UNITED STATES PATENT AND TRADEMARK OFFICE

Office Action Summary

09/752,651

FINAL OFFICE ACTION

Fig. 6

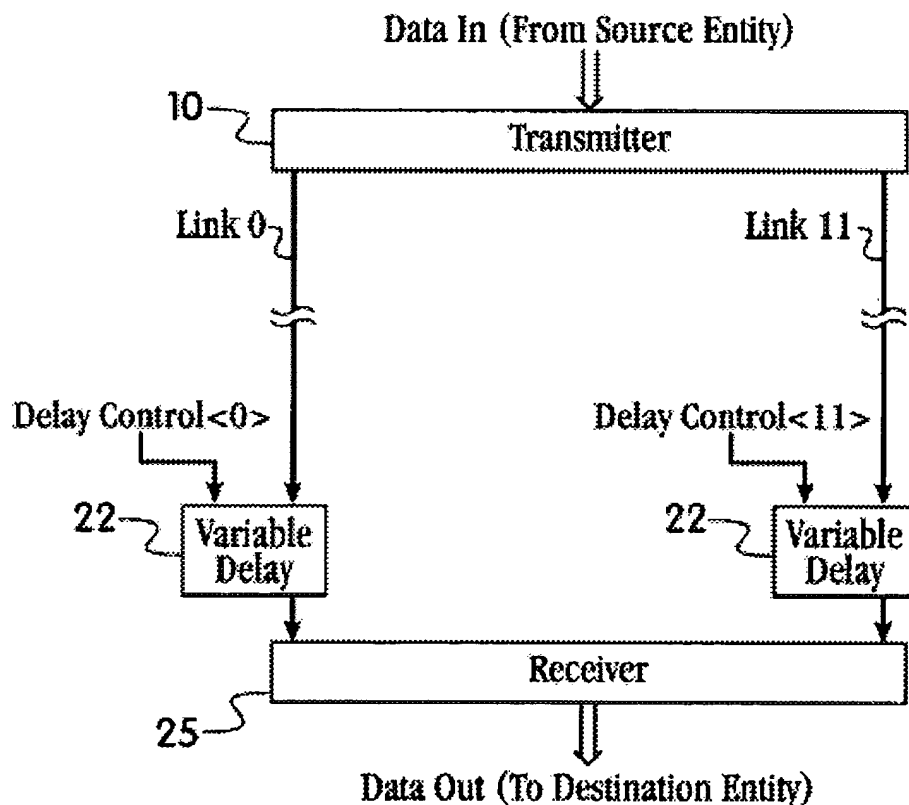
As per Claims 1-24, Widmer depicts, e.g., in Fig. 6 and related description in col. 1 line 13 et seq., the claimed method, comprising: a) measuring a skew between a data signal and a clock signal at a receiving end of a serial link; and b) adjusting (col. 2 line 27) a phase relationship between said data signal (col. 2 line 30) and said clock signal (col. 2 line 29) to reduce said skew via variable delay means implementable in hardware or software, e.g., in CPU or other digital component: Refer, e.g., to Fig. 6: block 22 and col. 2 line 23 et seq.

Widmer further teaches means to impose delay on one or both signals as seen in Fig. 6. And wherein said adjusting a phase relationship further comprises adjusting a phase offset between a pair of phasors associated with a pair of phase interpolators, a first of said phasors used to derive a second clock signal that times the transmission of said data signal, a second of said phasors used to derive said clock signal in col. 2 line 27 wherein equivalent means are provided for eliminating skews via multiple values of a period to effectively result in phase interpolation means. Also refer to Fig. 6 wherein variable delay blocks 22 are configured to delay signals on the links by more than 360 degrees.
